# TECHNICAL BULLETIN

FUJI HEAVY INDUSTRIES LTD.

NO. 200-020

1. SUBJECT : Installation of Strength Increased Tube for Control Column
2. AIRCRAFT AFFECTED : All FA200 series aircraft S/N 12 and subsequent.
3. PRIORITY : Desirable.

FIGURE 1

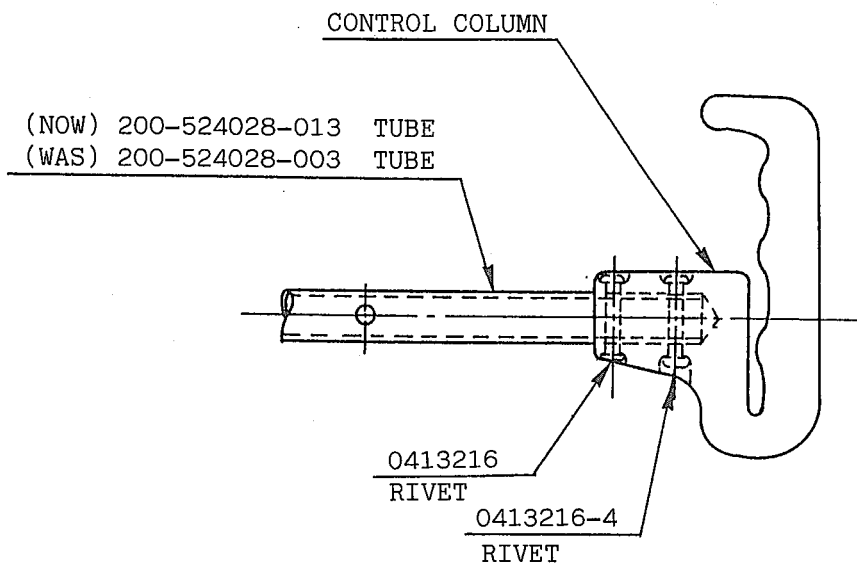
- (1) Remove control column assembly in accordance with Service Manual, Paragraph 8-2-7.
      - (2) See Figure 1. Remove rivents P/N 0413216 and 0413216-4, and disconnect tube P/N 200-524028-003 from control column.

- (3) Install new tube P/N 200-524028-013 with rivets 0413216 and 043216-4.
- (4) Install control column assembly in accordance with Service Manual, Paragraph 8-2-7. Replace nuts NAS679A3W with new nuts at installation. If NAS679A3 nuts are not available, MS21042L3 or equivalent self-locking nuts may be used as alternate.

FIGURE 2

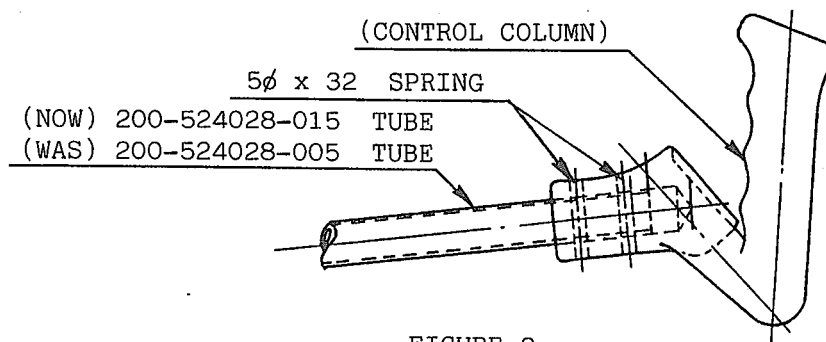
- (1) Remove control column assembly in accordance with Service Manual, Paragraph 8-2-7.
- (2) See Figure 2. Remove spring pins 5 $\phi$  x 32, and disconnect tube P/N 200-524028-005 from control column.

- (3) Install new tube P/N 200-524028-015 with new spring pins 5 $\phi$  x 32.
- (4) Install control column assembly in accordance with Service Manual, Paragraph 8-2-7. Replace nuts NAS679A3W with new nuts at installation.

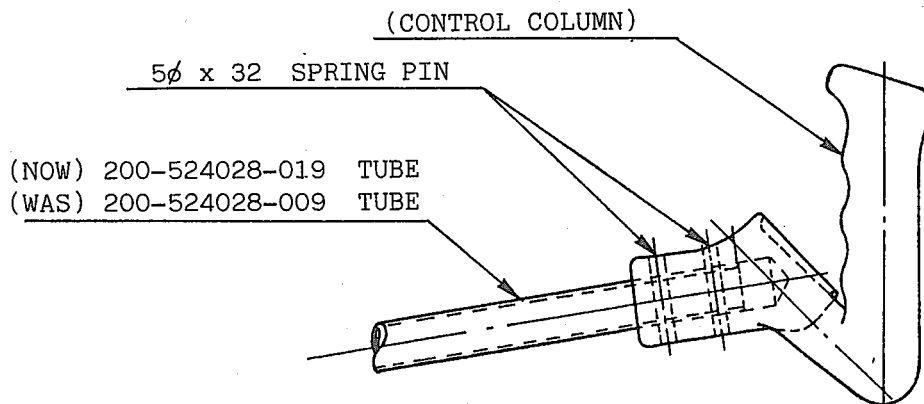
- (1) See Figure 3. Cut two wires at butt connectors which connect wire and curl cord extending from control column tube.
- (2) Remove the above tiedown straps.
- (3) Remove control column assembly in accordance with Service Manual, Paragraph 8-2-7.
- (4) See Figure 4. Remove spring pins  $5\phi \times 32$ , and disconnect tube P/N 200-524028-009 from control column.

- (5) Remove two wires located inside control column and tube (see figure 3).
- (6) Install two, new wires 20-B4B-9 (slightly longer than the removed wires) through control column and new tube 200-524028-019. Install switch and related parts, in the reverse order of removal, as shown on figure 3.
- (7) Install new tube P/N 200-524028-019 with new spring pins 5ø x 32 (see figure 4).
- (8) Install control column assembly in accordance with Service Manual, Paragraph 8-2-7. Replace nuts NAS679A3W with new nuts at installation.
- (9) Using two butt connectors, connect wires and curl cord removed from tube, and secure with two tiedown straps T-18R (see figure 3).

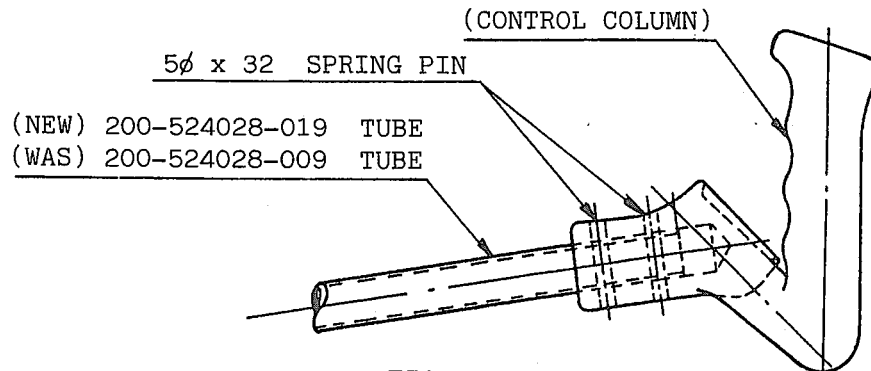
- (1) See figure 5. Cut four wires at butt connectors which connect wire and curl cord extending from control column tube.
- (2) Remove the above tiedown straps.
- (3) Remove control column assembly in accordance with Service Manual, Paragraph 8-2-7.
- (4) See figure 6. Remove spring pins  $5\phi \times 32$ , and disconnect tube P/N 200-524028-009 from control column.

- (5) Remove four wires located inside control column and tube (see figure 5).
- (6) Install four, new wires (slightly longer than the removed wires) through control column and new tube P/N 200-524028-019. Install switch and related parts, in the reverse order of removal, as shown on figure 5.
- (7) Install new tube P/N 200-524028-019 with new spring pins 5 $\phi$  x 32 (see figure 6). Replace nuts NAS679A3W with new nuts at installation.
- (8) Using four butt connectors, connect wires and curl cord removed from tube, and secure with two tiedown straps T-18R (see figure 5).
